**CITY OF MERIDIAN  
FINDINGS OF FACT, CONCLUSIONS OF LAW  
AND DECISION & ORDER**

**In the Matter of the Request for Annexation of 20.5-Acres of Land with a R-15 Zoning District; and Preliminary Plat Consisting of 144 Building Lots and Eleven (11) Common Lots on 20-Acres of Land for the Hadler Subdivision, by Conger Group.**

**Case No(s). H-2022-0064**

**STAFF REPORT**  
**COMMUNITY DEVELOPMENT DEPARTMENT**

Sheet Number  
**L1**

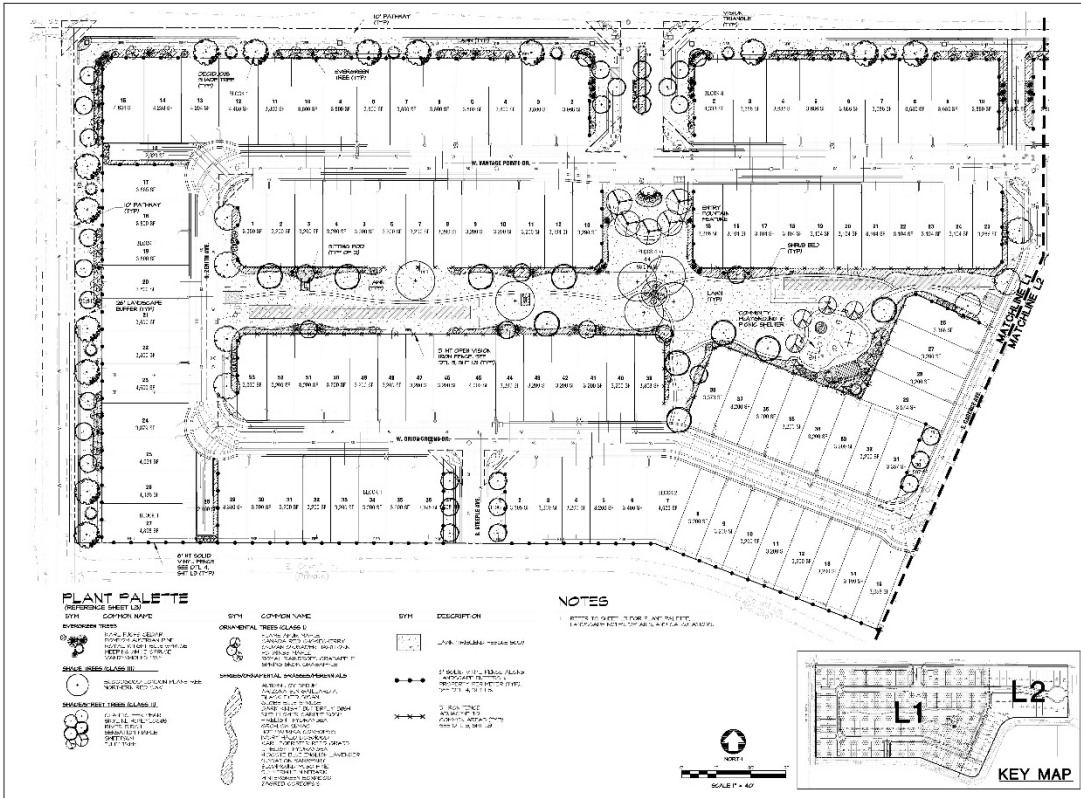
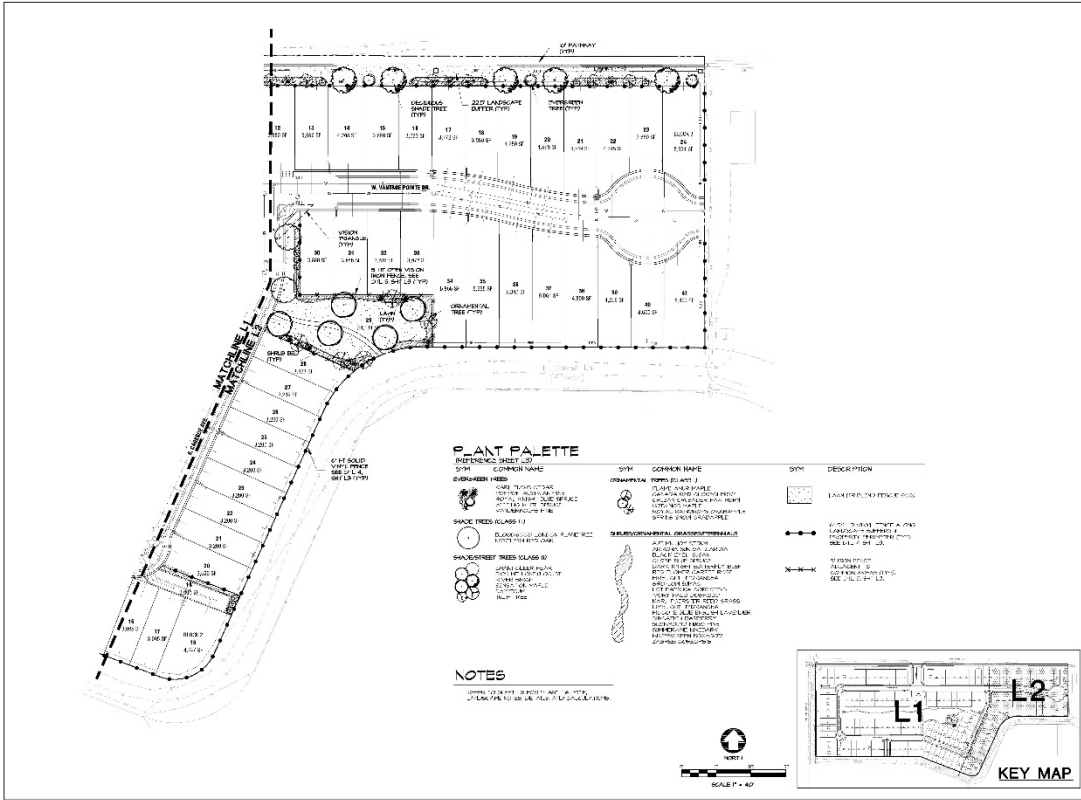
*The pathway along Locust Grove appears to be attached to Locust Grove which does not comply with the UDC or Master Pathways Plan. So, the Applicant should revise the plat and landscape plan to depict this 10-foot pathway to be located within the required 25-foot buffer to Locust Grove and at least four (4) feet outside of the ultimate ROW to ensure the pathway remains detached.*

*The Applicant is showing a 25-foot wide common lot along Locust Grove that is a 22.5-foot wide common lot along Via Roberto consistent with code requirements. The landscape buffers are depicted with trees in excess of code and include landscape beds with shrubs and other vegetative ground cover, consistent with UDC 11-3B-7. Therefore, Staff finds the proposed street buffers comply with all UDC requirements. In addition, all open space areas are shown with trees, sod, and other landscaping in excess of minimum code requirements.*

*the smaller common open space area along the southeast boundary. However, Staff is not sure if the landscape buffers to the adjacent public streets meet the enhanced buffer requirements outlined in UDC 11-3G-3B.3 to count towards the open space. Previously, these areas automatically qualified towards the minimum open space but this is no longer the case with the latest open space code updates that desires for more than the minimum to be included within the required buffers in order to count towards the overall qualified open space for a project. The Applicant appears to comply with the first two points outlined in code but may not comply with the last two points: enhanced amenities with social interaction characteristics; and, enhanced context with the surroundings.*

***Staff recommends the Applicant provide evidence these buffers are enhanced beyond the pathway, trees, and grasses. For example, boulders, additional vegetation, decorative elements, decorative fence/walls, additional micro-pathways, etc. The burden of proof for the proposed common open space to qualify falls on the Applicant and not on Staff.***

3. The landscape plan included in Section VII.C, dated July 29 November 2, 2022, shall be revised as follows prior to submitting for Final Plat approval:

- a. Revise the landscape plan to match the revisions made to the street section of Vantage Pointe Drive on the latest preliminary plat.
  - b. Make the necessary revisions to the landscape plans to match the plat revisions noted above in VIII.A2.

### D. Open Space Exhibit:

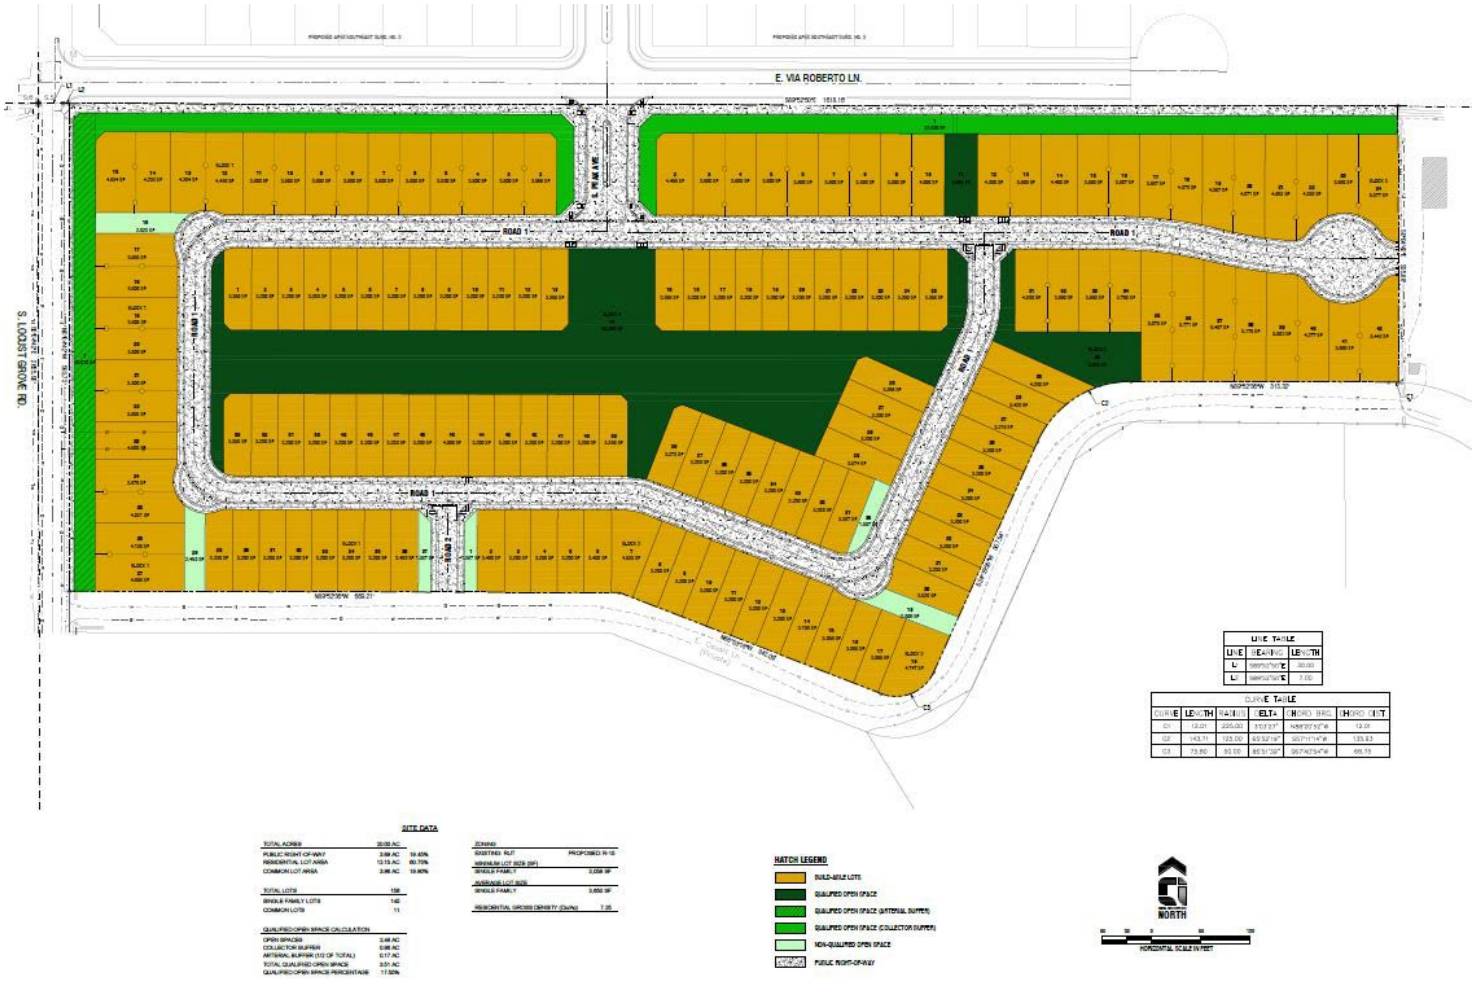
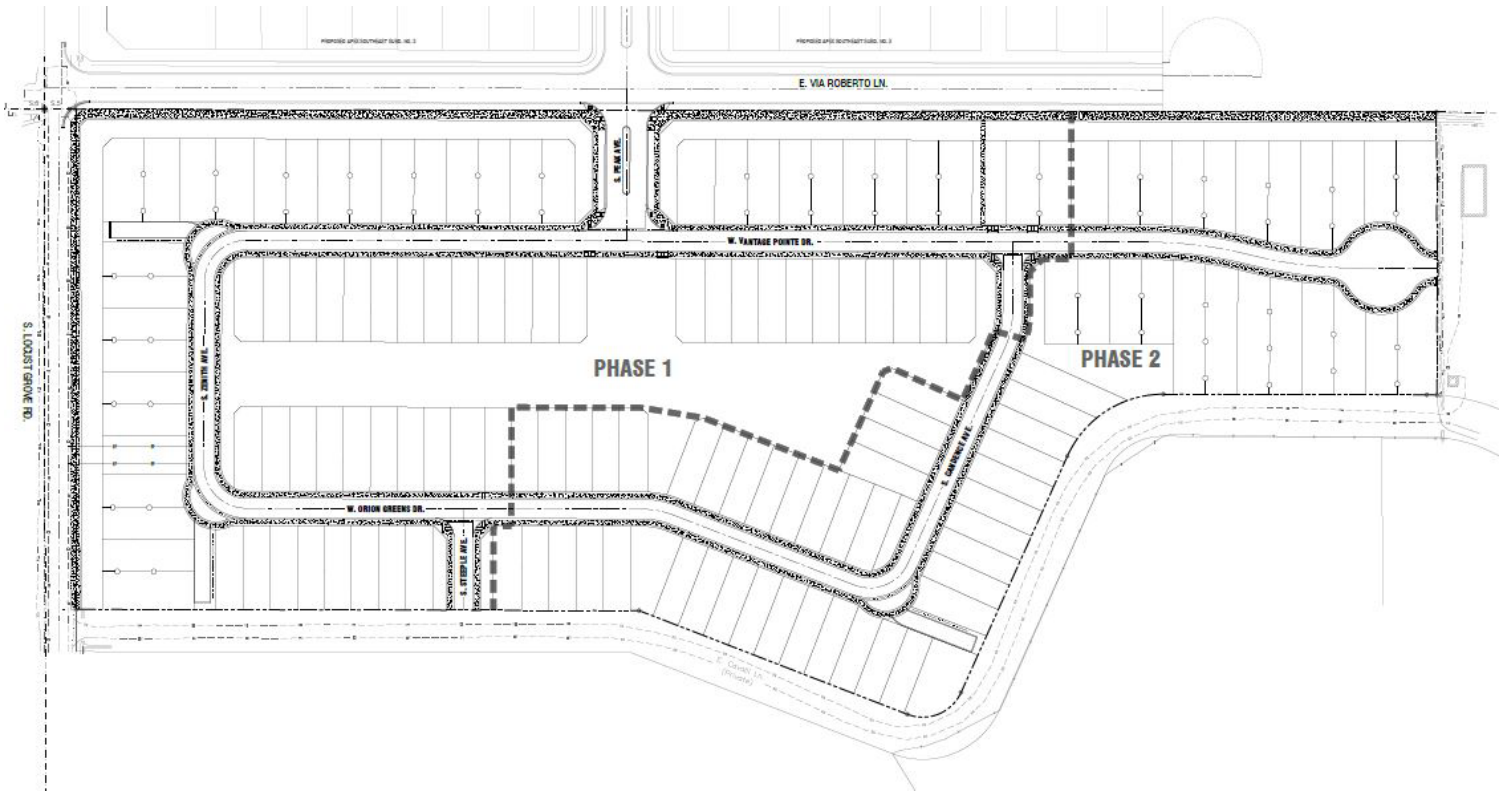
*The qualified open space proposed consists of ½ of the arterial street buffer to Locust Grove, the full collector street buffer to Via Roberto, the large central open space area, and*

***If these buffers do not count towards the minimum qualified open space, approximately 1 acre of land must be removed from the calculation leaving approximately 2.5 acres of qualified open space which does not comply with the minimum qualified open space requirement. Therefore, the Applicant should provide evidence that the proposed street buffers are qualified open space prior to the Commission hearing OR apply for Alternative Compliance to reduce the amount of qualified open space required due to the project's proximity to Discovery Park to the northeast.***

4. Prior to the Commission hearing, the Applicant shall provide evidence that the proposed street buffers are qualified open space OR apply for Alternative Compliance prior to the City Council hearing to request a reduction to the amount of qualified open space required.

F. Common Drive Exhibits:

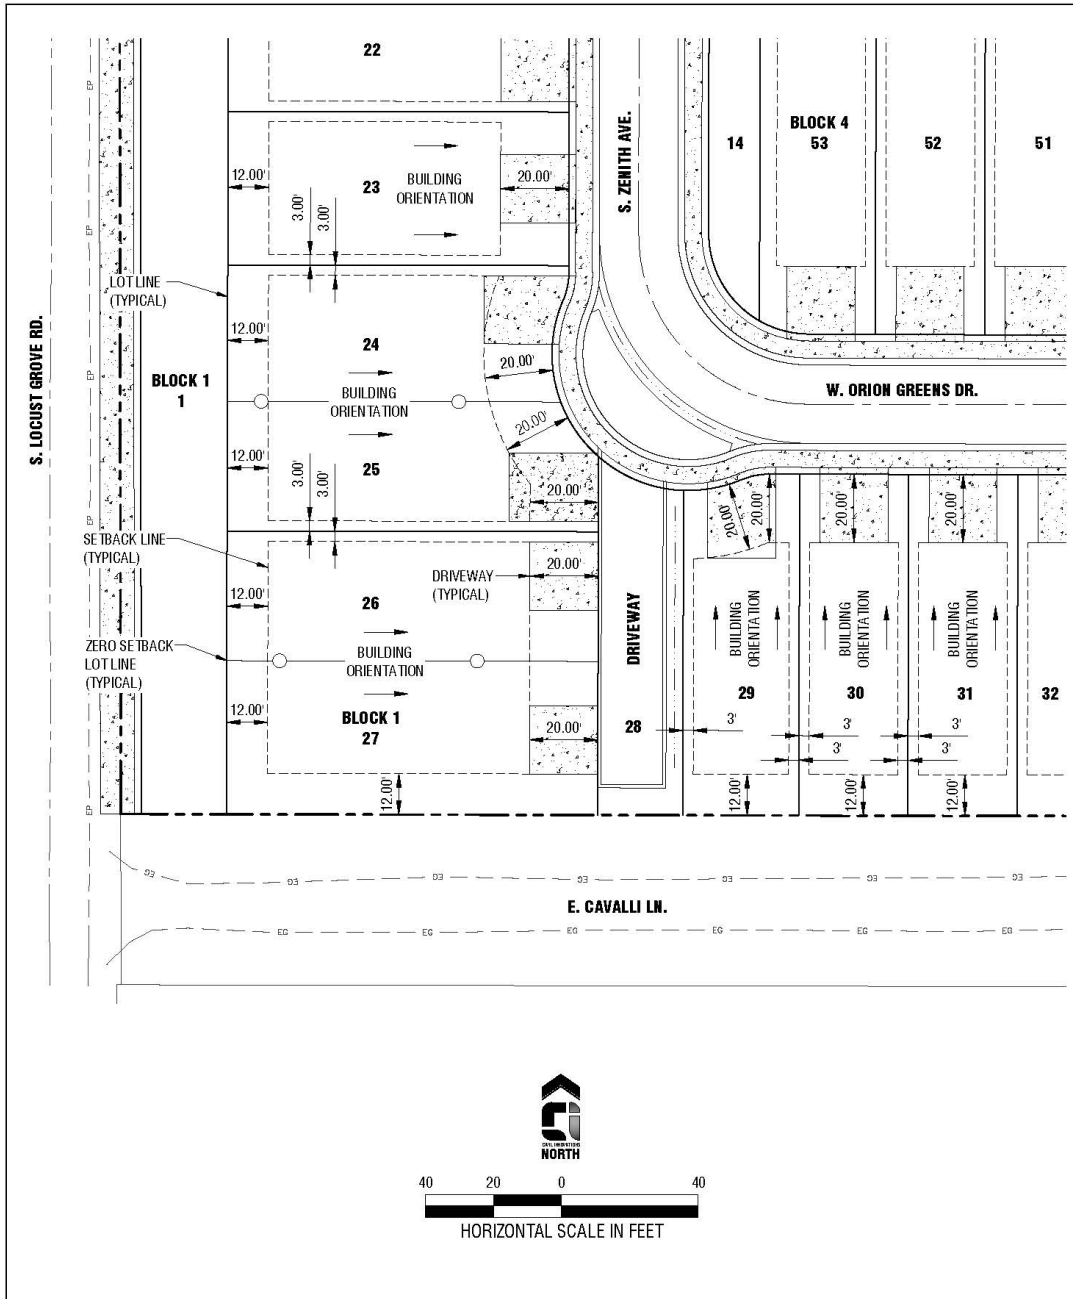
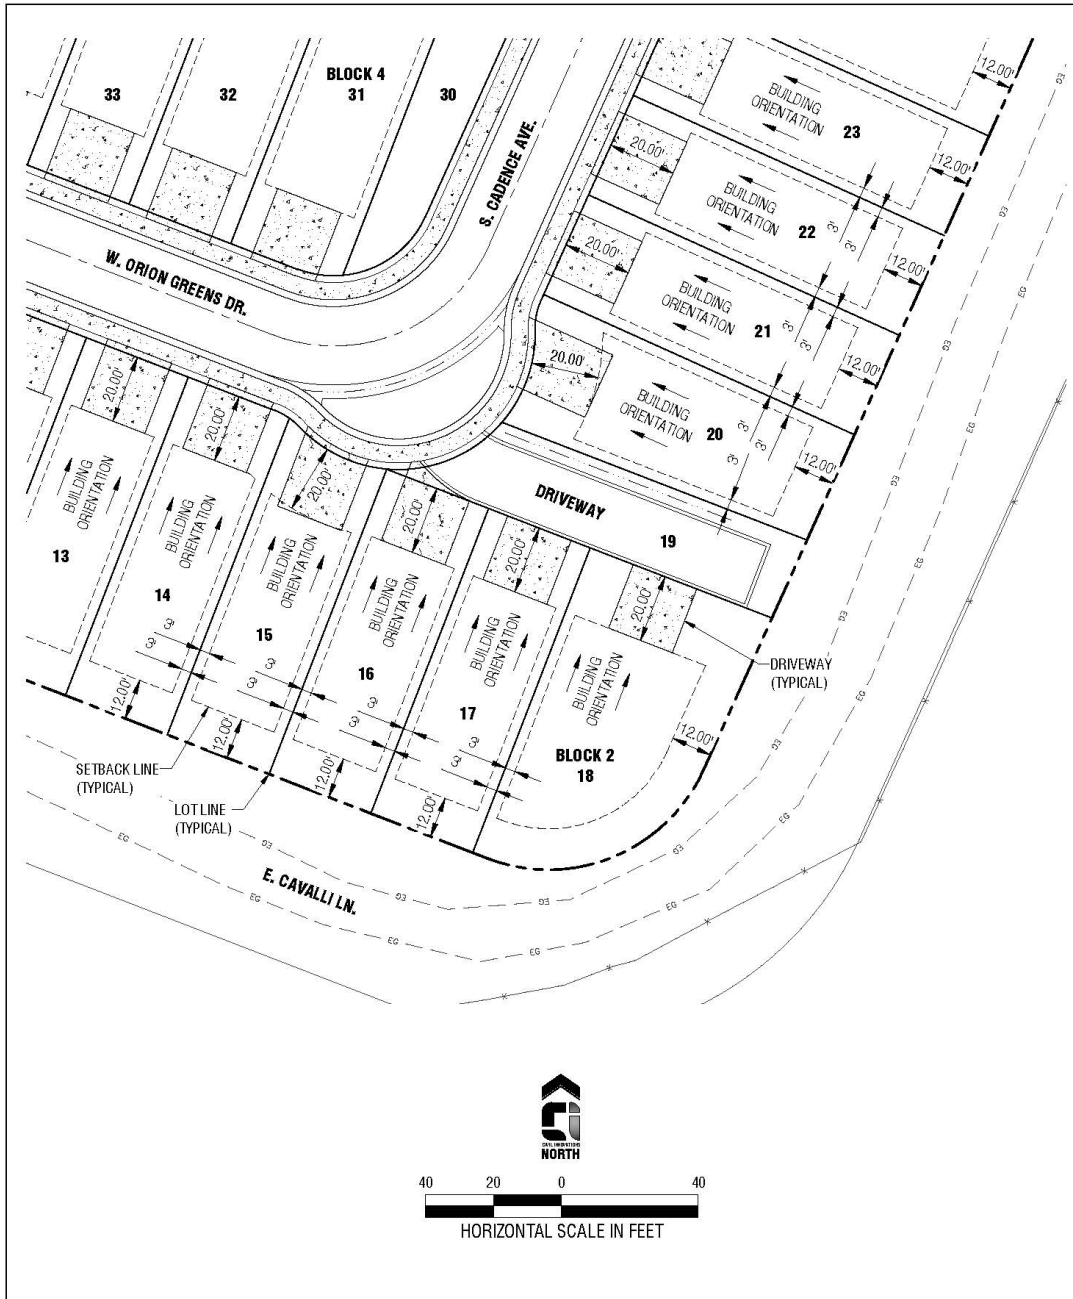
*The three (3) proposed common drives depict 3 lots taking access from each of them and include at least 5 feet of landscaping adjacent to the abutting lot not taking access from the common drive. The proposed common drive design complies with UDC 11-6C-3D requirements.*
